| CHANGE DATE | CHANGE DESCRIPTION                              | CHANGE NO.                   | NAME | <div>SportsArt</div> <div>FITNESS</div> <div>RESTRICTED USAGE ,</div> <div>PLEASE DON'T FORWARD TO ANYONE WHO ISN'T AUTHORIZED</div> |  | DRAWN BY |  | UNITS   | MM   | SALES BLOW UP DIAGRAM | DIAGRAM NO. | TBK-F101B-C    |

| CHANGE DATE | CHANGE DESCRIPTION                                                                                                                                                                       | CHANGE NO.   | NAME | <div>SportsArt</div> <div>FITNESS</div> <div>RESTRICTED USAGE ,</div> <div>PLEASE DON'T FORWARD TO ANYONE WHO ISN'T AUTHORIZED</div> | DRAWN BY    |  | UNITS | MM | SALES BLOW UP DIAGRAM | DIAGRAM NO. | TBL-F101C-E |

| CHANGE DATE | CHANGE DESCRIPTION    | CHANGE NO.   | NAME | <div>SportsArt</div> <div>FITNESS</div> <div>RESTRICTED USAGE ,<br/>PLEASE DON'T FORWARD TO ANYONE WHO ISN'T AUTHORIZED</div> |  | DRAWN BY | UNITS   | MM   | SALES BLOW UP DIAGRAM | DIAGRAM NO. | TBL-F101D-C |

| CHANGE DATE |  | CHANGE DESCRIPTION

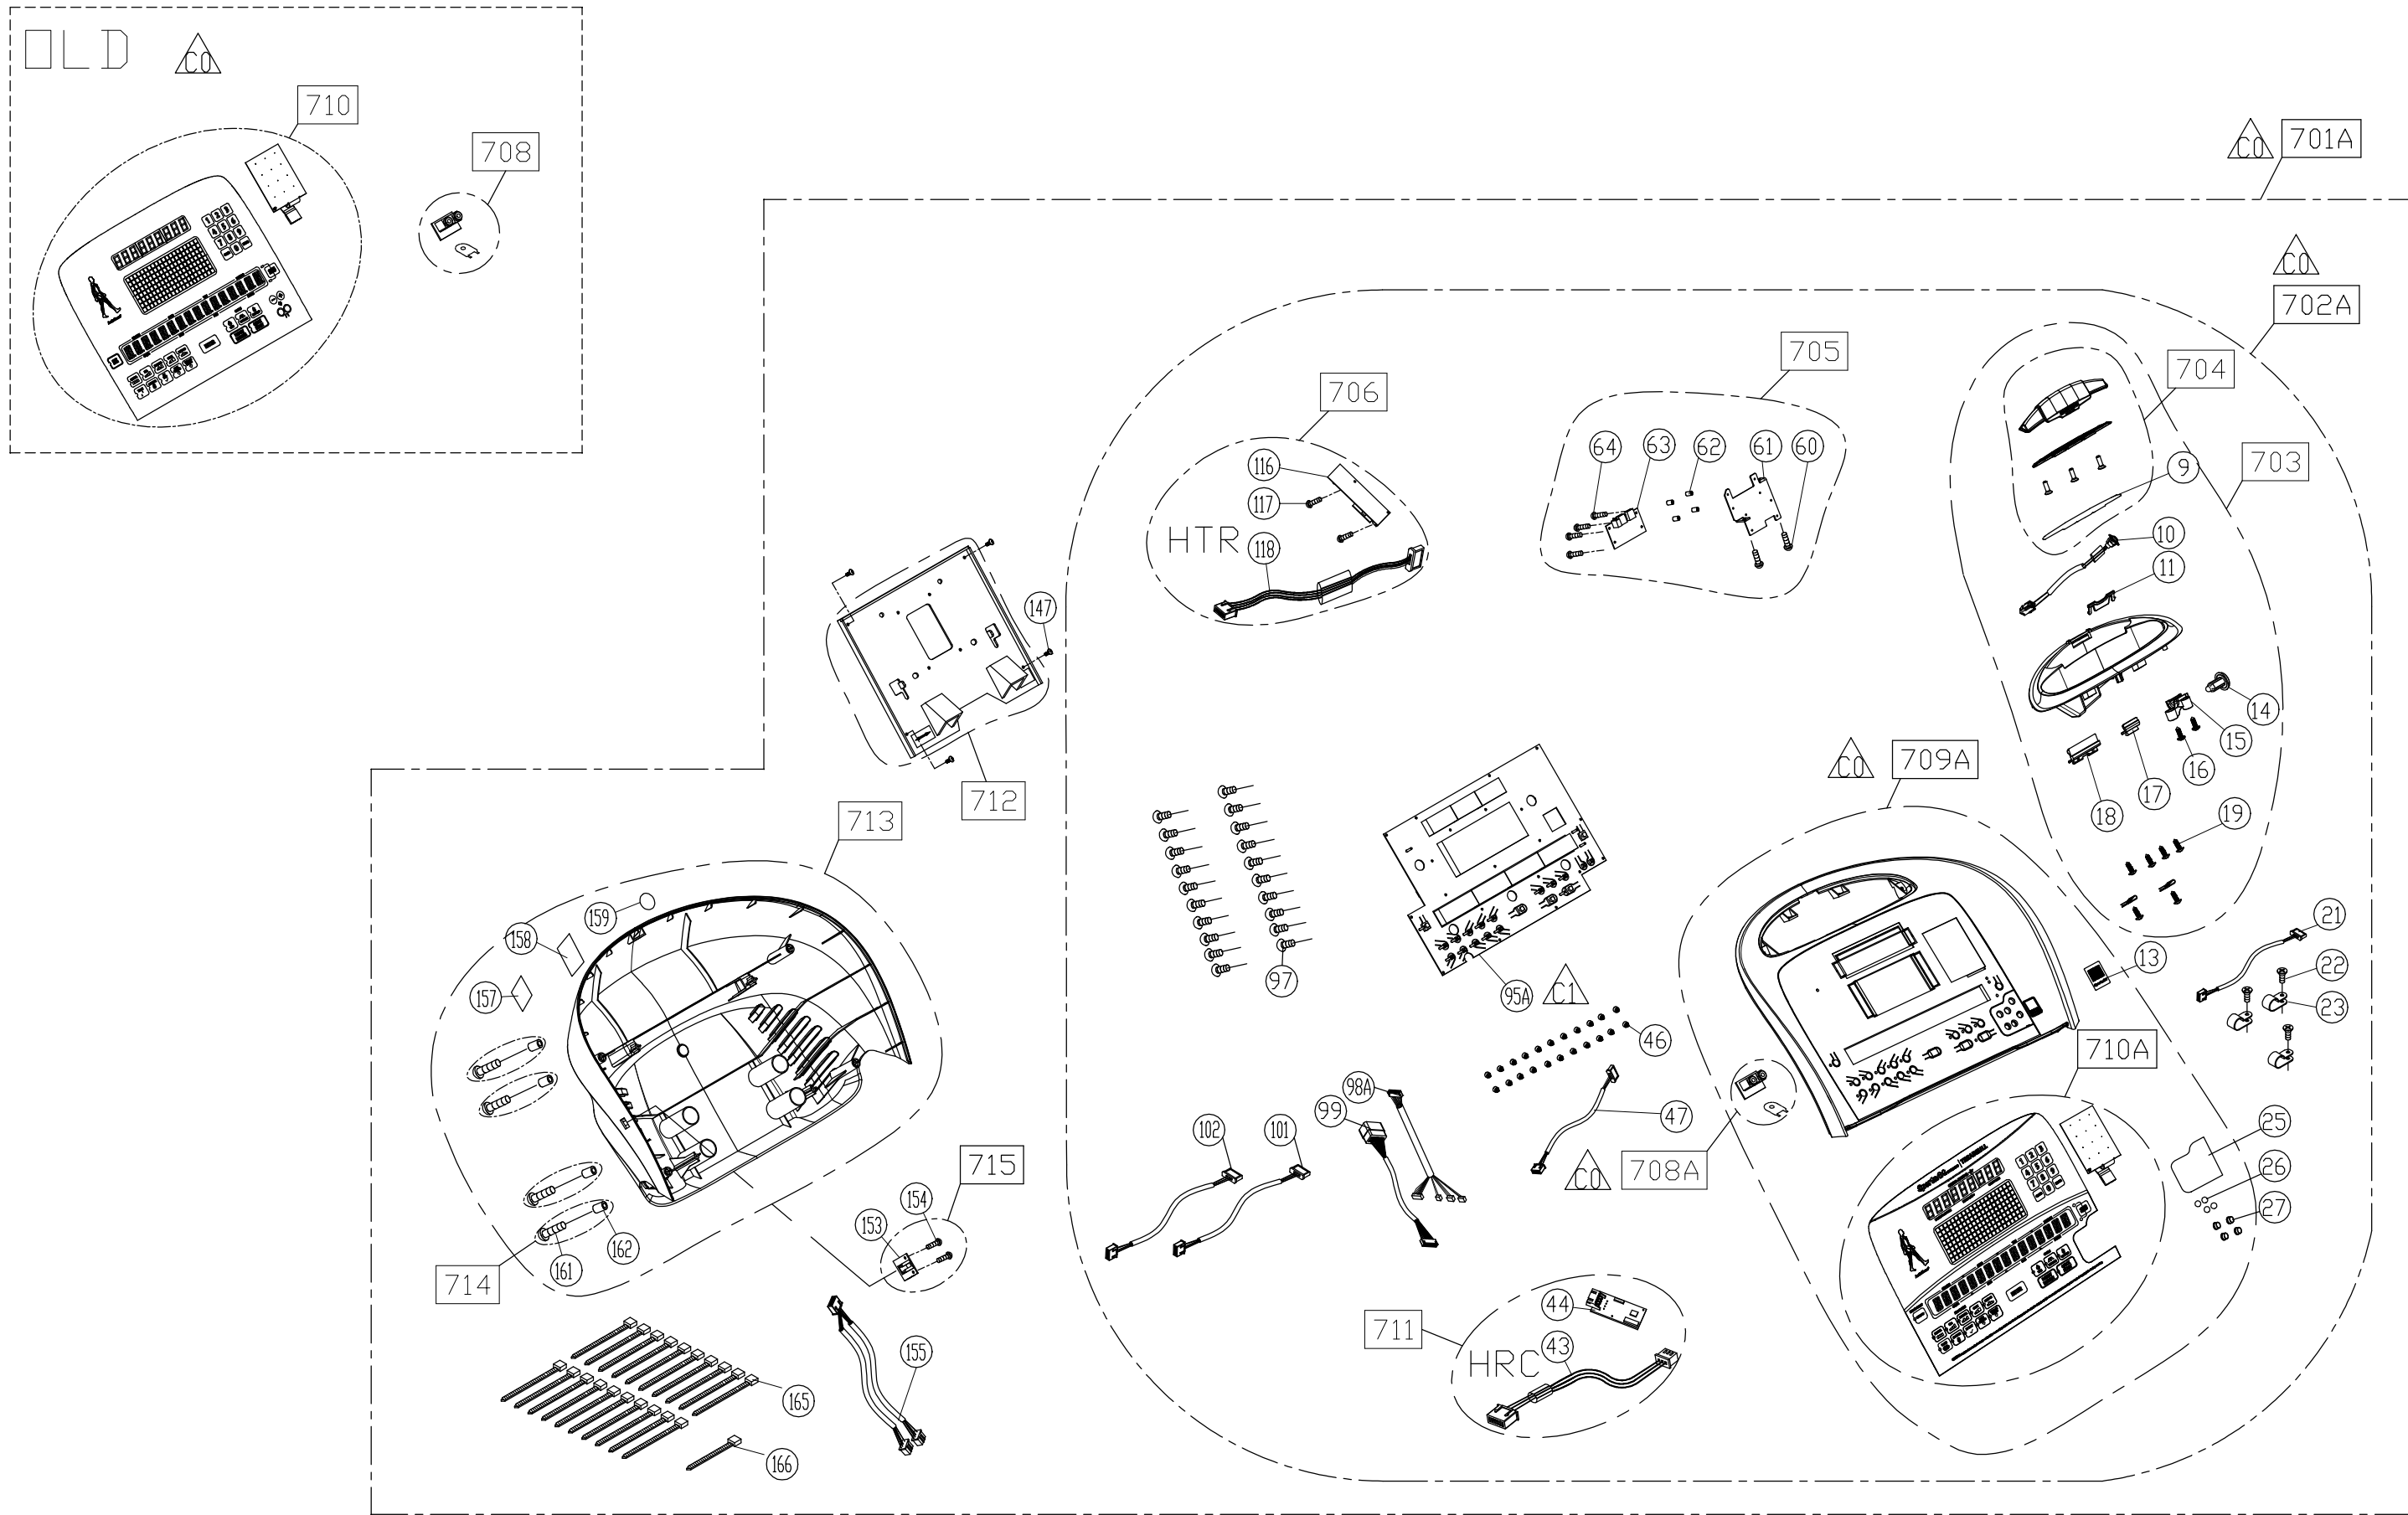
| CHANGE DATE | CHANGE DESCRIPTION                              | CHANGE NO.                   | NAME | <div>SportsArt</div> <div>FITNESS</div> <div>RESTRICTED USAGE ,</div> <div>PLEASE DON'T FORWARD TO ANYONE WHO ISN'T AUTHORIZED</div> |  | DRAWN BY |  | UNITS   | MM   | SALES BLOW UP DIAGRAM | DIAGRAM NO. | TBK-F101B-C    |
|-------------|-------------------------------------------------|------------------------------|------|--------------------------------------------------------------------------------------------------------------------------------------|--|----------|--|---------|------|-----------------------|-------------|----------------|
| 2015.01.05  | BO 98改98A, 排線新品須搭配新版橋接小板                        | 02-20140801T                 | 楊勝文  |                                                                                                                                      |  |          |  | QTY     | 1    |                       |             | T645/T655/T635 |
| 2015.09.18  | CO 增加TV WAR功能, 新增A29, 變更組件為701A702A709A710A715A | 02-20141036M<br>02-20141036T | 潘衍耀  |                                                                                                                                      |  |          |  | VERSION | C1   | XX                    |             | T616           |
| 2015.11.27  | C1 新控制板已將程式轉接小板電路合併, 故95改95A, 並取消50707          | 02-20150901T                 | 黃柏勳  |                                                                                                                                      |  |          |  | RATIO   | 1:10 |                       |             | (LED)          |

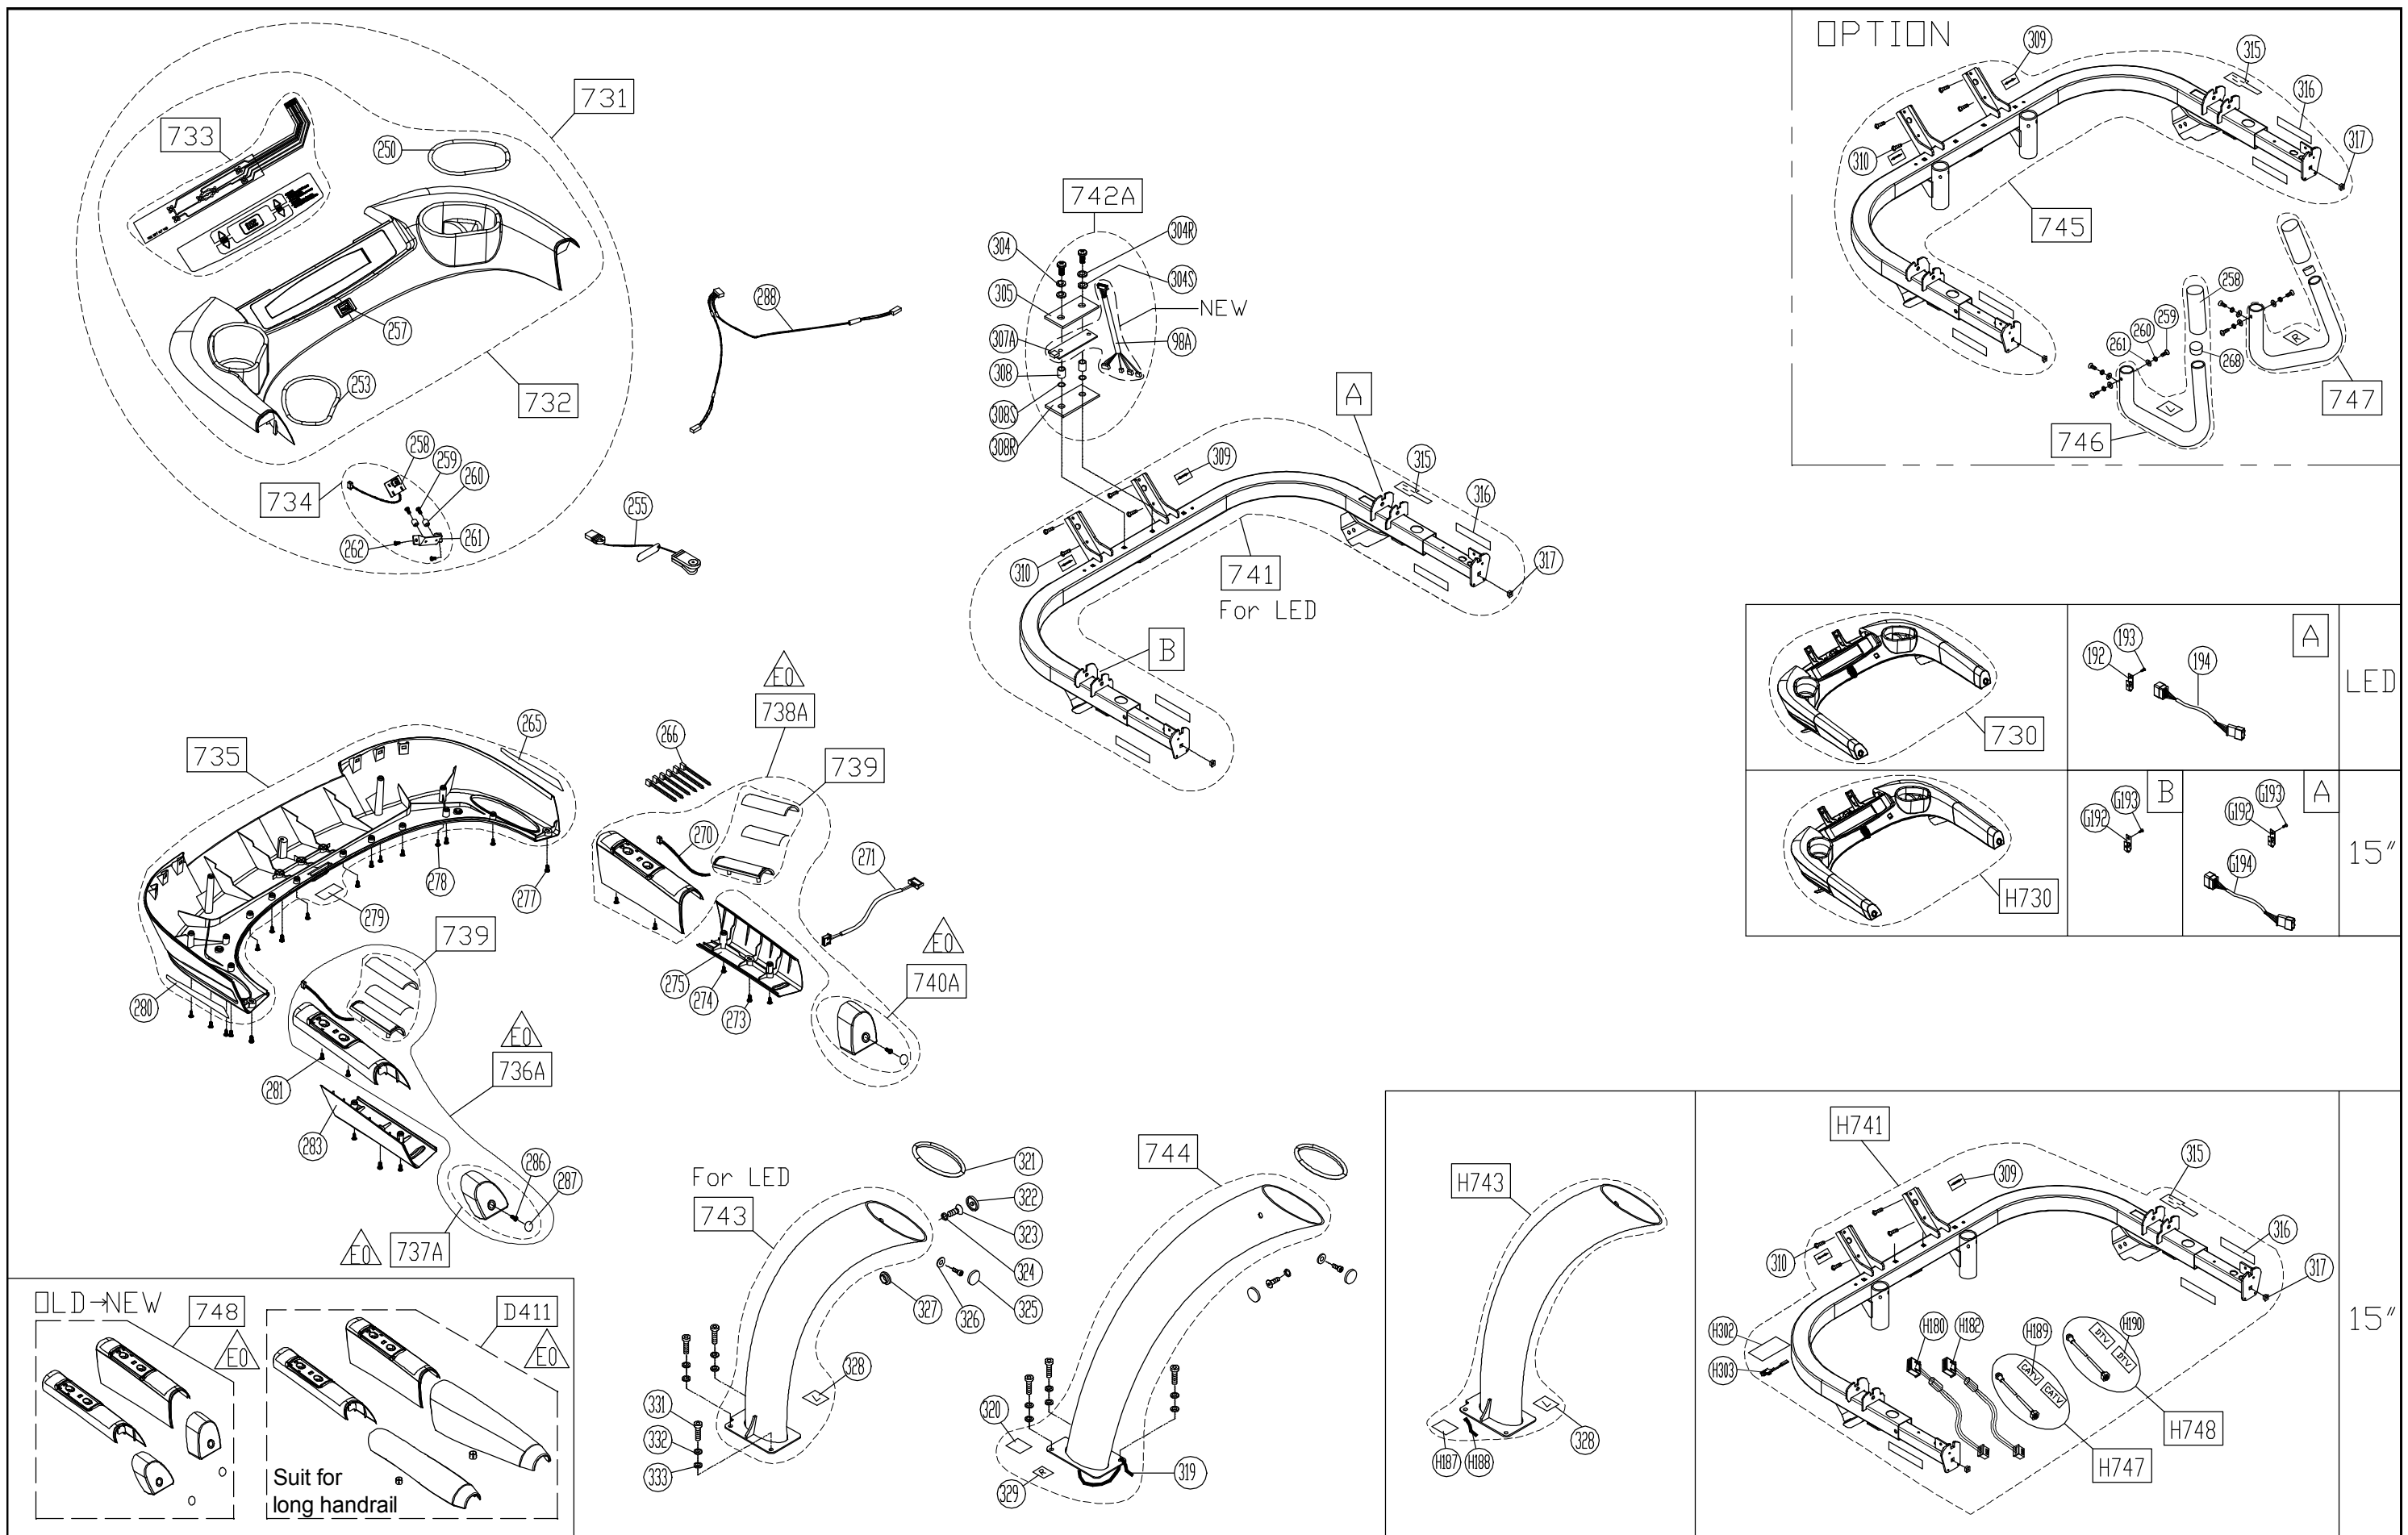
| CHANGE DATE | CHANGE DESCRIPTION                                                                                                                                                                       | CHANGE NO.   | NAME | <div>SportsArt</div> <div>FITNESS</div> <div>RESTRICTED USAGE ,</div> <div>PLEASE DON'T FORWARD TO ANYONE WHO ISN'T AUTHORIZED</div> | DRAWN BY    |  | UNITS | MM | SALES BLOW UP DIAGRAM | DIAGRAM NO. | TBL-F101C-E |
|-------------|------------------------------------------------------------------------------------------------------------------------------------------------------------------------------------------|--------------|------|--------------------------------------------------------------------------------------------------------------------------------------|-------------|--|-------|----|-----------------------|-------------|-------------|
| 2015.06.09  | <div>D0</div> 15吋Panel 固定板與喬接小板干涉, 修改 <div>308</div> 規格, 追加 <div>308R</div>                                                                                                              | 02-20150608M | 陳銘濤  |                                                                                                                                      | VERIFIED BY |  | QTY   | 1  | XX                    | MODEL       | T645        |
| 2015.09.30  | 扶手護蓋補強, 舊換新須搭配寄整組 <div>748</div> <div>D411</div> <div>736</div> 改 <div>736A</div> <div>738</div> 改 <div>738A</div> , <div>737</div> 改 <div>737A</div> , <div>740</div> 改 <div>740A</div> | 02-20150619M | 楊淵堯  |                                                                                                                                      |             |  |       |    |                       |             |             |
| 2015.04.01  | <div>C0</div> 新增15吋料件                                                                                                                                                                    |              | 尤淑芬  |                                                                                                                                      |             |  |       |    |                       |             |             |
